# Access Compliance Report

## Public Rights-of-Way

### (Curb Ramps)

Intersection ID: 42923	Main Street: BRAY_DR	Cross Street: LIFFORD_DR	Location: W
ADA ID: 14A65B8532A4	Ramp Type: PerpDiag	Initial Pass/Fail: Fail	Overall Compliance: No
Severity Score: 42.5			
Codes/Mitigation Info/Possible Solution		Field Measurements/Component Compliance

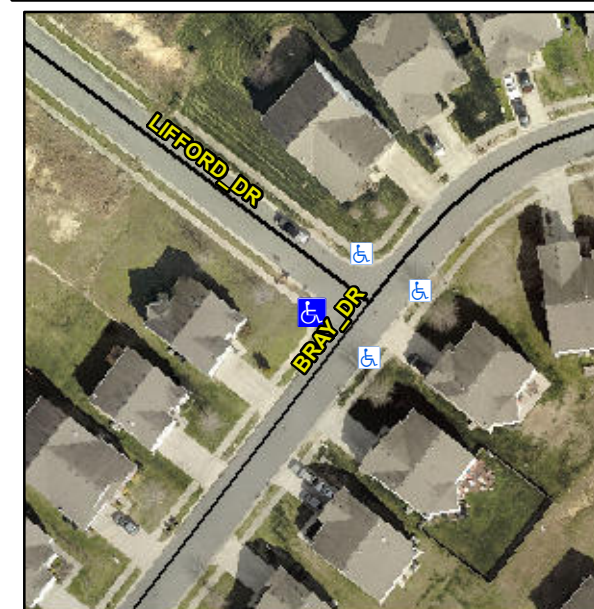
**Not Found, R304.5.1, R304.2.2, R304.5.3**

Compliance	Description	Data	Compliance	Description	Data
N/A	Ramp Length (in)	48.0	No	Ramp Slope (%)	8.4
No	Ramp Width (in)	34.0	No	Ramp XSlope (%)	6.3
N/A	Flare Type LT	N/A	N/A	Flare Type RT	N/A
N/A	Flare Slope LT (%)	N/A	N/A	Flare Slope RT (%)	N/A
N/A	Flare Traversable LT?	N/A	N/A	Flare Traversable RT?	N/A
N/A	Landing Length (in)	N/A	N/A	DWS Provided?	N/A
N/A	Landing Width (in)	N/A	N/A	DWS Contrast?	N/A
N/A	Landing Slope (%)	N/A	N/A	DWS Length (in)	N/A
N/A	Landing X Slope (%)	N/A	N/A	DWS Full Width?	N/A
N/A	Landing Curb? (Y/N)	N/A	N/A	DWS Offset (in)	N/A
N/A	Shared Landing?	N/A			
N/A	Gutter Ponding?	N/A	N/A	Gutter Slope (%)	N/A
N/A	Gutter Lip Ht (in)	N/A	N/A	Gutter X Slope (%)	N/A
N/A	Painted X Walk1?	No	N/A	Painted X Walk2?	No
	X Walk 1 Direction	To SE		X Walk 2 Direction	To NE
N/A	X Walk 1 Width (in)	N/A	N/A	X Walk 2 Width (in)	N/A
	X Walk 1 Slope (%)	5.4		X Walk 2 Slope (%)	0.5
	X Walk 1 X Slope (%)	3.8		X Walk 2 X Slope (%)	4.6

**Remove & Replace Curb Ramp With Two New Directional Ramps or Equivalent.**
